AMENDMENTS TO THE DRAWINGS

Please replace drawing sheets 2, 3, 5, 6, and 7 with the newly-submitted figures attached herewith on separate sheets labeled “Replacement Sheet.” A marked-up copy of these sheets is also included for further explanation, labeled “Annotated Sheet.” The following are the changes and/or corrections made to the drawings:

REMARKS

Fig. 3

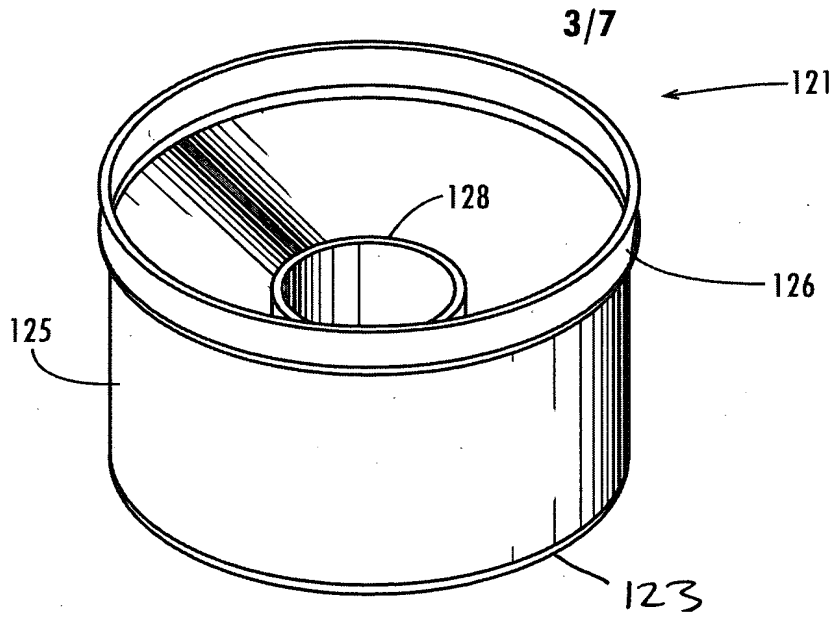
Fig. 3:

- 1) added reference 123 for base

Fig. 7

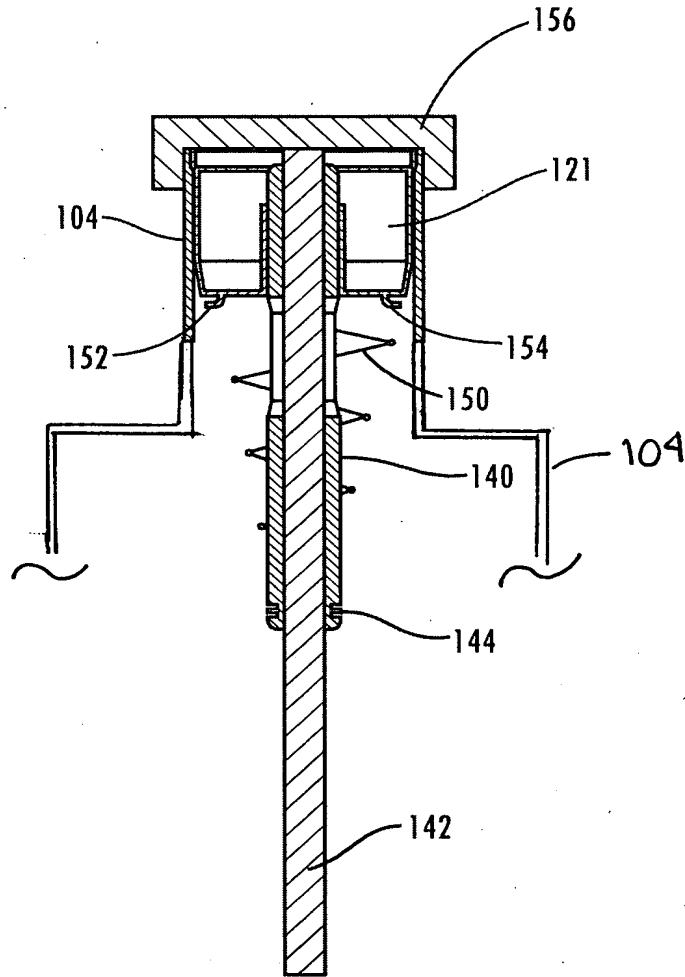
Fig. 7:

- 1) added reference for reservoir 104
- 2) modified structure of reservoir 104

Fig. 8

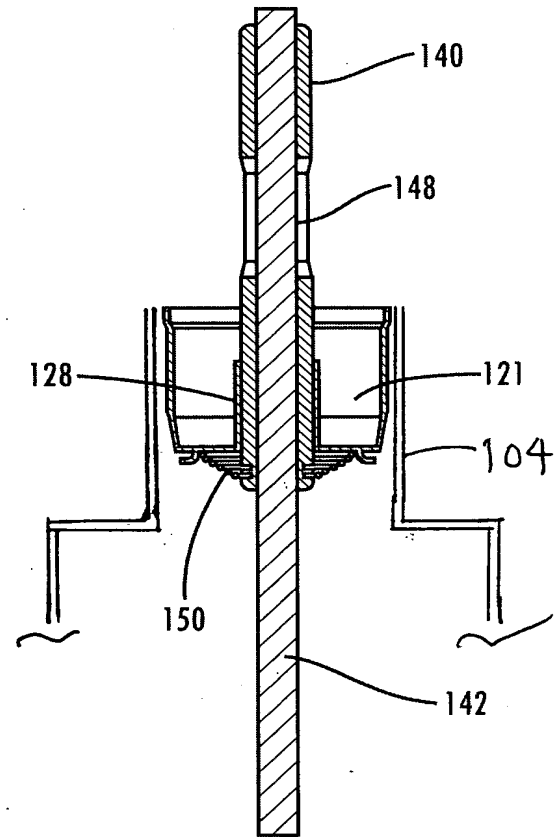
Fig. 8:

- 3) added reference for reservoir 104
- 1) modified structure of reservoir 104

Fig. 9

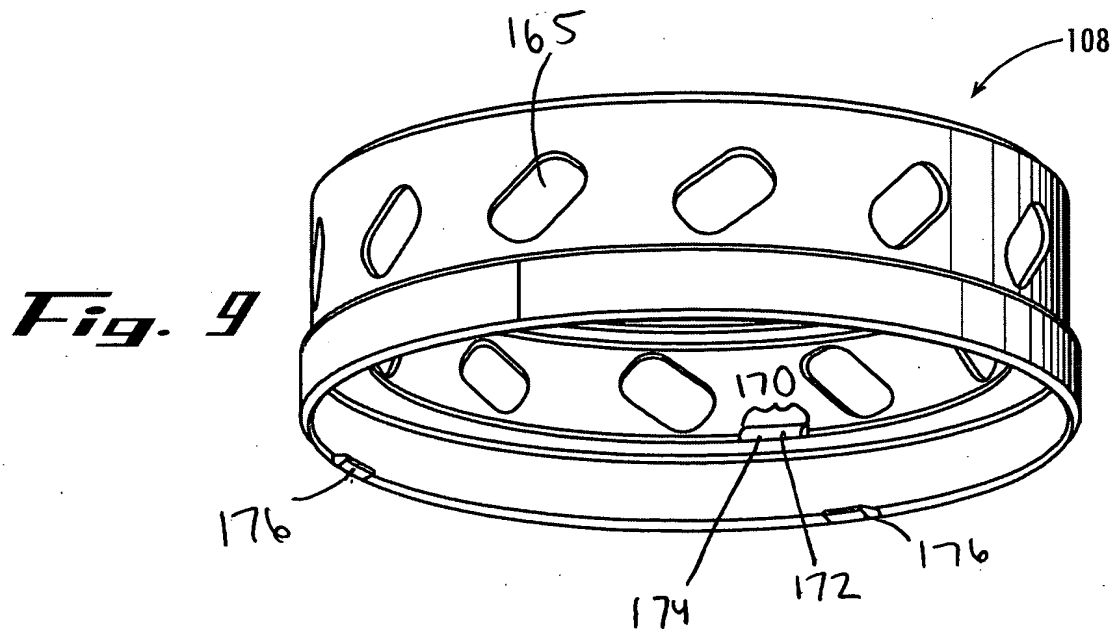
Fig. 9:

- 1) added reference 165 for vent hole
- 2) added reference 170 for mechanical stop
- 3) added reference 172 for pin
- 4) added reference 174 for slot
- 5) added reference 176 for tab

The drawings have been objected to under 37 CFR 1.84(p)(5). Specifically, the Office Action states that the drawings “do not include the following reference sign(s) mentioned in the description: in Figures 9 and 10: vent holes 165, mechanical stop 170, pin 172, and slot 174; and in Figure 9: base 161, tabs 176, and exterior threads 178.”

A proposed drawing correction to Figure 9 is submitted with this Response. The correction shows newly added reference signs for base 161, holes 165, stop 170, pin 172, slot 174, and tabs 176. A proposed drawing correction to Figure 10 is also submitted with this response. The correction shows newly added reference signs for holes 165. Applicants respectfully submit these corrections overcomes the drawing objection with regard to reference numerals 161, 165, 170, 172, 174, and 176 in Figures 9 and 10.

Fig. 10

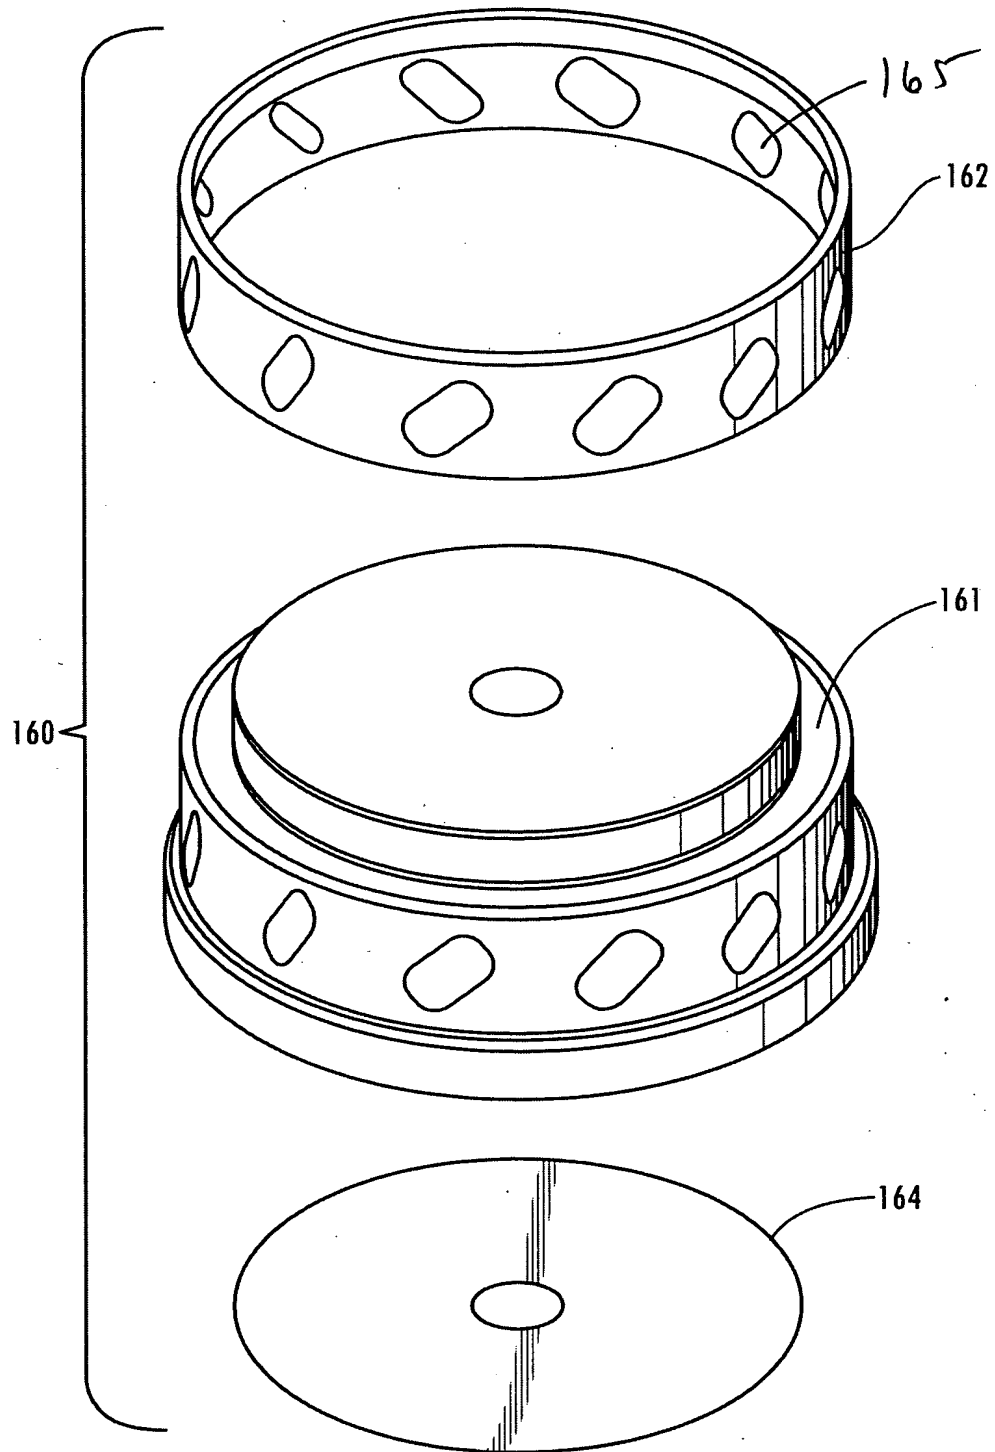
Fig. 10:

- 1) added reference 165 for vent hole

Finally, Applicants have amended the description of stop 170, pin 172 and slot 174 (Specification, p. 7, line 19 to p. 8, line 3) to refer only to Figure 9, rather than to Figures 9 and 10. Applicants respectfully submit that this specification amendment overcomes the drawing objection with regard to Figure 10 and reference numerals 170, 172 and 174.

Fig. 11

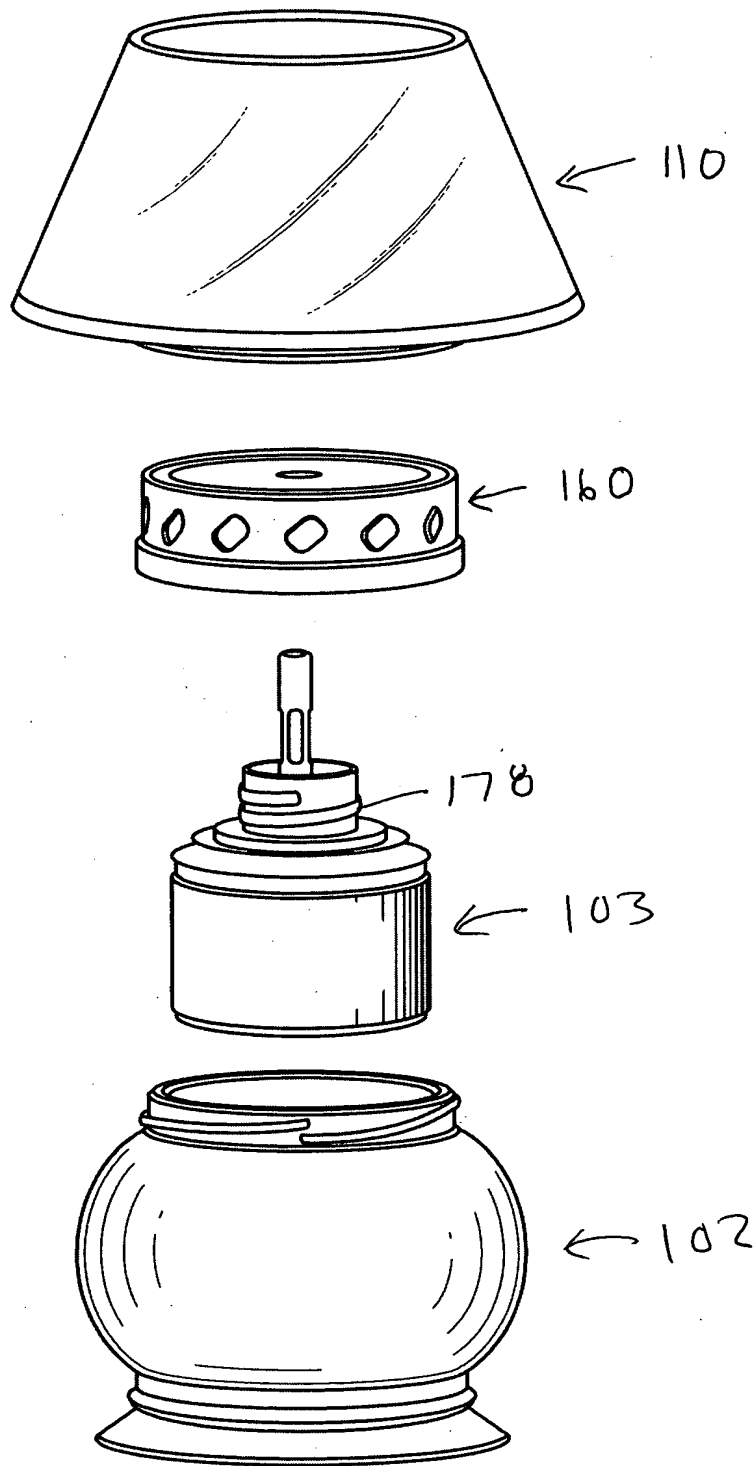
Fig. 11:

- 1) added reference 102 for base
- 2) added reference 103 for fuel-supply module
- 3) added reference 110 for shade
- 4) added reference 160 for adjustable collar assembly
- 5) added reference 178 for external threads

Applicants respectfully traverse the drawing rejection as it relates to exterior threads 178 and Figure 9. The reference to threads 178 in the specification refers to Figure 11, not Figure 9: “Referring briefly to FIG. 11, these tabs are sized and arranged to engage exterior threads 178 formed at an upper edge of lamp base 102.” (Specification, p. 8, lines 9-10.) Applicants respectfully request that the drawing objection with regard to Figure 9 and reference numeral 178 be withdrawn.
